Subject: Proposed Edits to WCAP 17096-NP, Revision 2

Subject: PWR Owners Group  
**Transmittal of Westinghouse Revised Text for Draft WCAP-17096-NP  
Revision 2 for Transmittal to EPRI for NRC Review, LTR-RIAM-13-97,  
Revision 1 (PA-MSC-0473R5)**

**Subject: Updates to WCAP-17096-NP Sections for Westinghouse and CE-Designed Plants**

CE-ID: 2  
Core Shroud Assembly (Welded) – Core Shroud Plate-Former Plate Weld

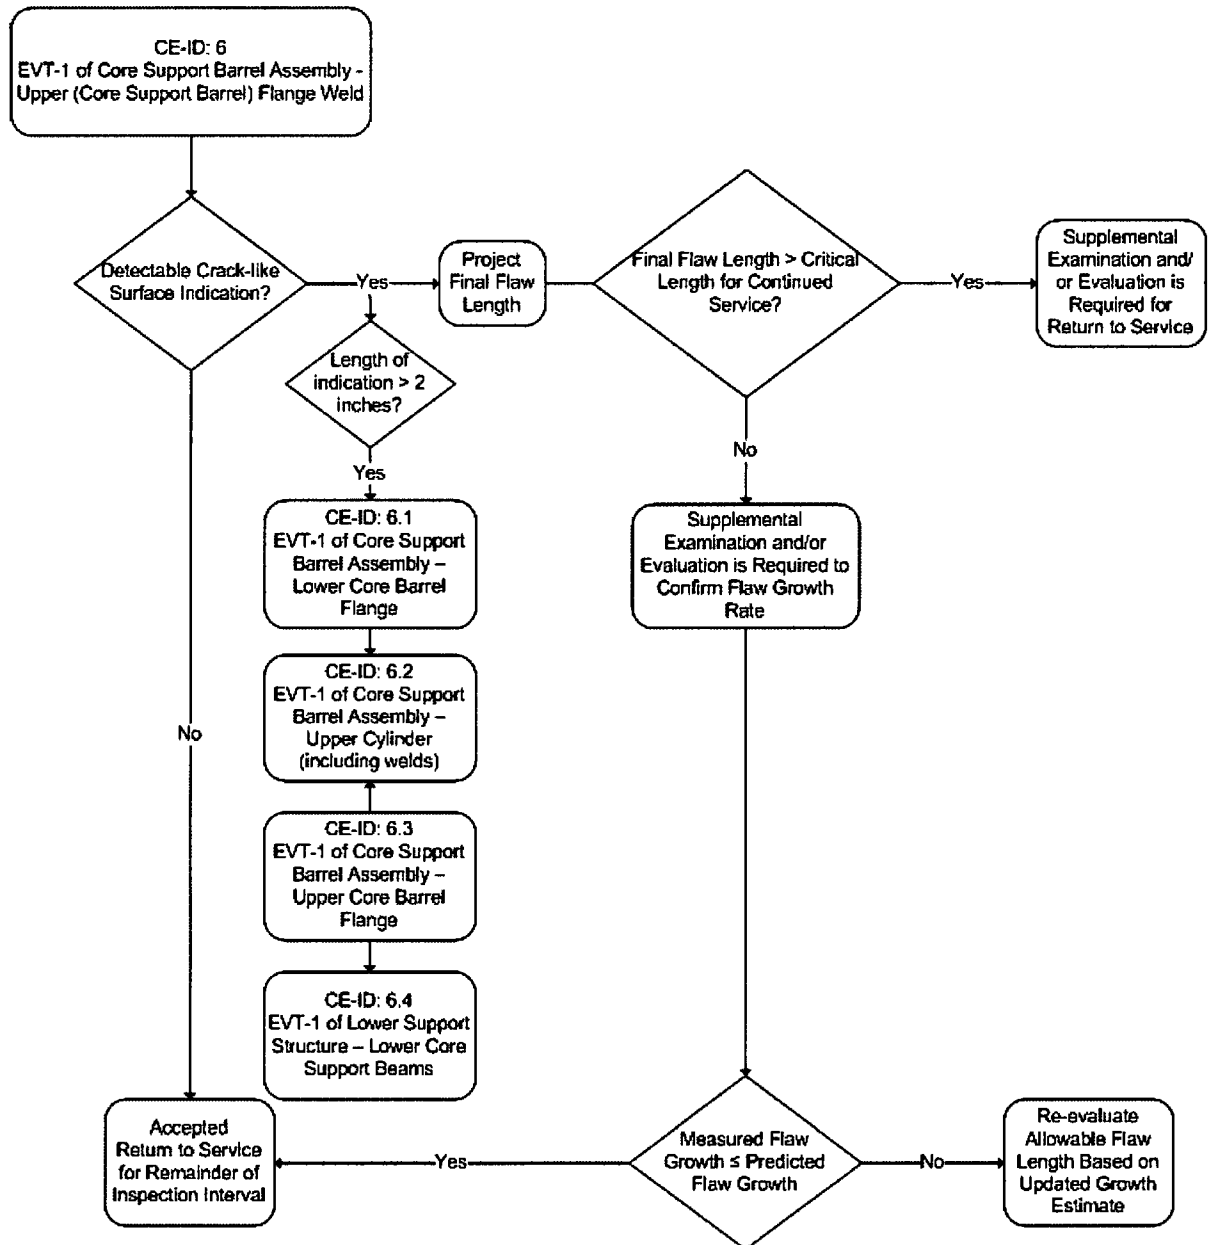
Attachment A contains updated sections and the corresponding revised flowcharts for Appendices C, D, E, and F in WCAP-17096-NP. These are Westinghouse and Combustion Engineering (CE) sections that required updates. Some of the sections have been renumbered, as can be seen in the attached revised Table of Contents for Appendices C, D, E, and F of WCAP-17096-NP. The renumbering was necessary to accommodate the elevation of some locations from "Expansion" to "Primary" status as a result of the NRC's review of MRP-227. Some of the updated sections contained in the attachment contain reference numbers. These numbers correspond to the references in WCAP-17096-NP, revision 2. Updating the WCAP is part of the scope under PWROG project authorization, PA-MS-C-0473 [1]. This letter includes the following updated sections:

CE-ID: 9  
Core Support Barrel Assembly – Lower Flange Flexure Weld

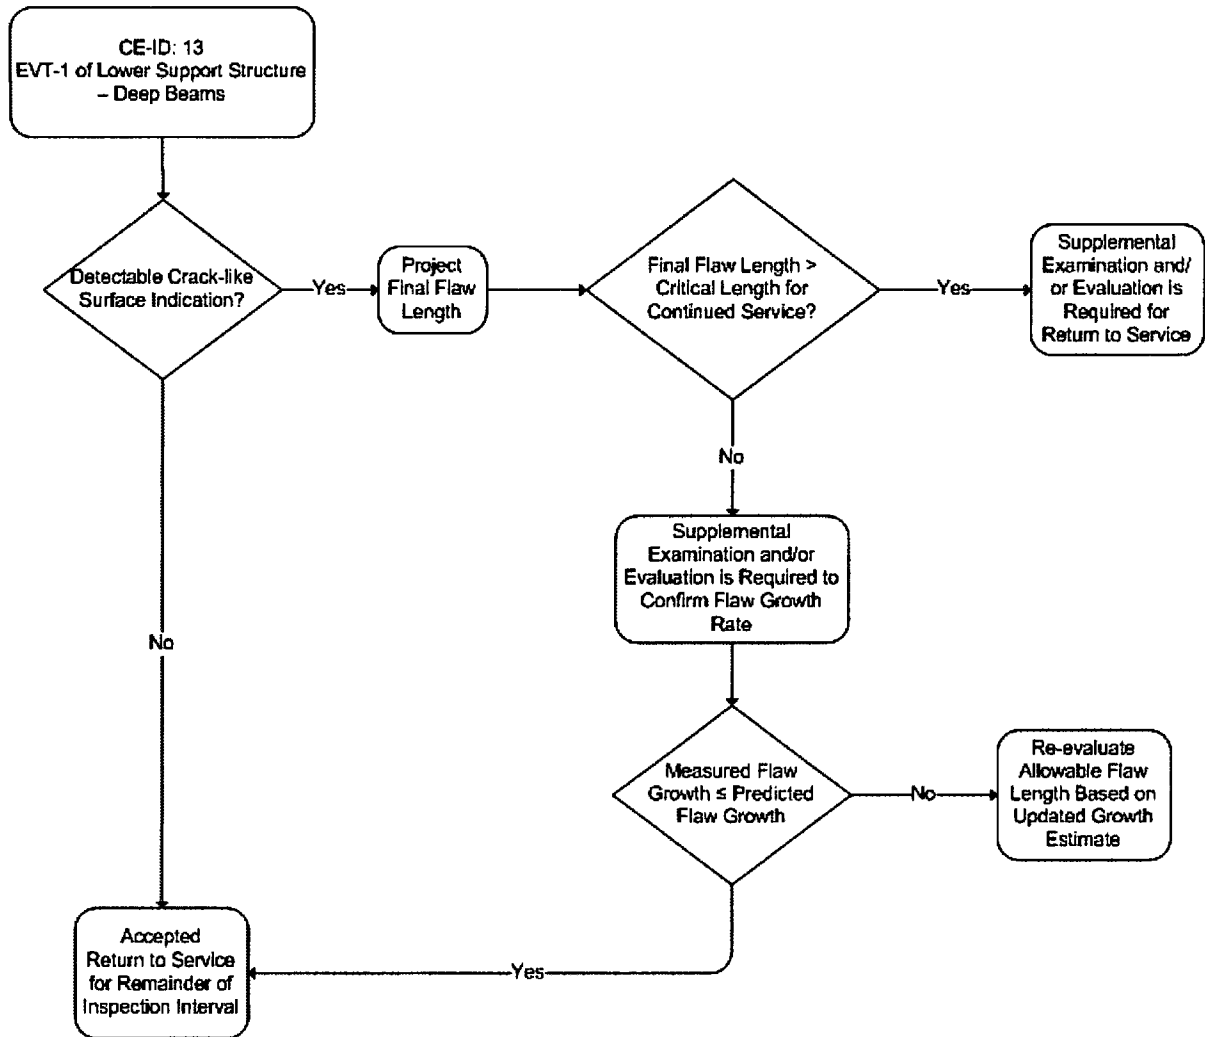
Westinghouse would like to note that the title and component description of CE-ID-9 has changed. The title and component description went from "Lower Flange Weld" to "Lower Flange Flexure Weld." This was done to more accurately reflect what is being inspected. The new title does not agree with MRP-227-A but Westinghouse plans to carry this change through when MRP-227 is revised.
